Salem Generating Station, Units 1 and 2
Renewed Facility Operating License Nos. DPR-70 and DPR-75
NRC Docket Nos. 50-272 and 50-311

Subject: Final Responses to NRC Questions Regarding Salem Bypass Testing

Attachment 1 Responses to NRC Questions Regarding Salem Bypass Testing During
Teleconference Held on November 28, 2012

Figure 5-1: Penetration Velocity Distribution

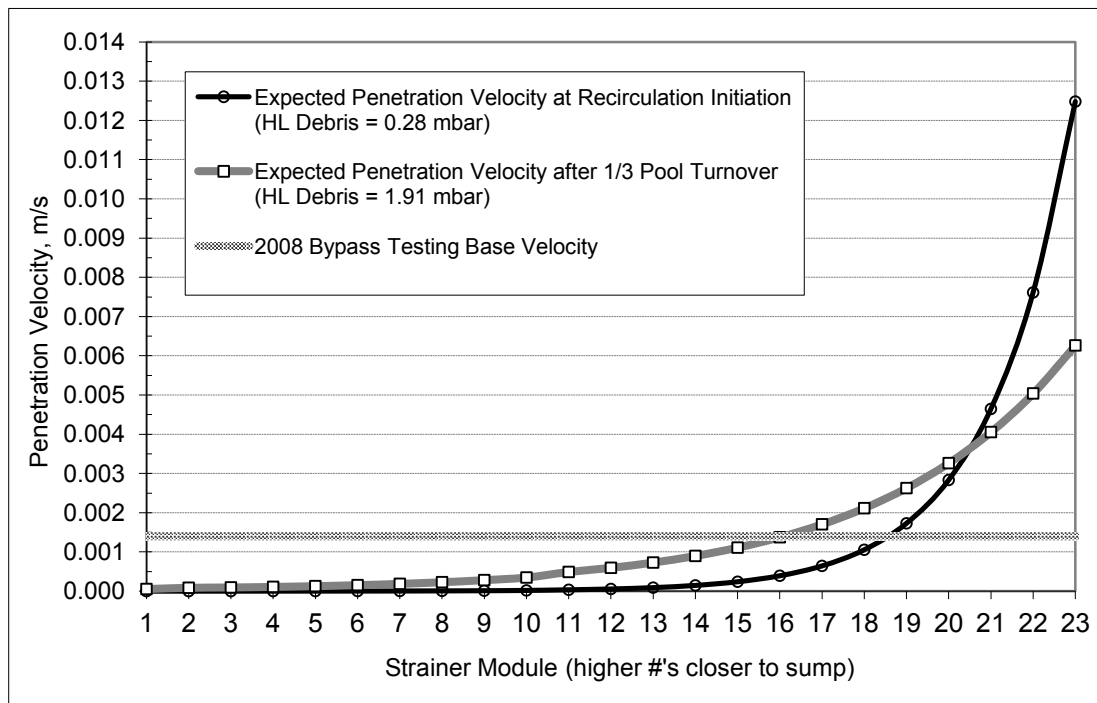
- 5) *The highest reported test velocities were about 80 times lower than the maximum expected velocity for the Salem strainer according to the vortex evaluation. How do velocity gradients of this magnitude affect bypass?***

To illustrate this point, a plot of the expected penetration velocities immediately after recirculation initiation and after 1/3 of a pool turnover is shown below. Note, while the strainer and sump pit fill with water before recirculation begins, approximately 2.3% of the fiber will reach the strainer (based on the volume of water in the strainer compared to the volume of water in the sump pool at recirculation initiation assuming uniform debris concentration). The Unit 1 debris load is selected since it has a less uniform penetration velocity distribution due to a lower overall debris head loss than Unit 2 (see Section 3f.10.2 of 2012 Supplemental Response); however, the debris load is conservatively applied to the Unit 2 strainer since it is smaller and therefore has higher penetration velocities. The plot of expected penetration velocity in each module was generated using the spreadsheets developed as part of the strainer head

loss calculation (see Section 3f.9 of 2012 Supplemental Response). Based on a uniform debris concentration in the sump pool, two pump flow, and the strainer head loss being directly proportional to the quantity of debris on the strainer, it is expected that the penetration velocity profiles shown in the figure below would develop quickly after recirculation initiation and after 1/3 of a pool turnover.

As shown in Figure 5-1, it is expected that at recirculation initiation approximately 75% of the strainer modules will experience penetration velocities lower than those tested in the 2008 CCI Bypass Tests. Furthermore, by the time 1/3 of a pool turnover has occurred (approximately 5 minutes after recirculation begins), the penetration velocities at the modules nearest the sump are already significantly lower.

Photo 10-1

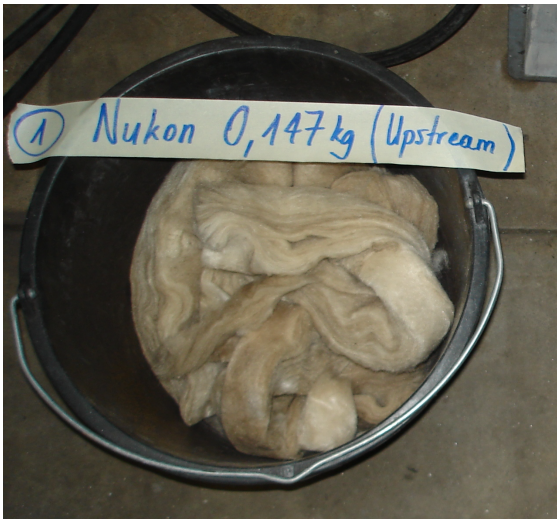
10) Discuss the procedures for debris control during the tests. How were the fibers ensured to all make it into the test tank after weighing and preparation?

The dry fiber material was weighed in separate buckets which were labeled with tape (see Photo 10-1). The dry material was then further divided into batches which were soaked with water prior to being blasted with a water jet. The fiber batches were placed in larger bucket(s) in order to accommodate water from the jet blasting. The quantity of debris in these larger buckets was also recorded and placed on a tape label on the bucket (red circle in Photo 10-2). The large buckets were not drained during the water jet blasting to ensure that no fiber fines were lost. The prepared fiber debris bucket was then placed on a scaffold near the MFTL and the fiber slurry was added to the test loop using the dip-bucket method where a pitcher was used to slowly add the debris to the MFTL (green circle in Photo 10-2).

Furthermore, given that the results of the fiber bypass tests indicate that the strainer reaches a fiber saturation value beyond which additional fiber does not result in significant bypass, the loss of a few fibers during preparation and addition would be inconsequential.
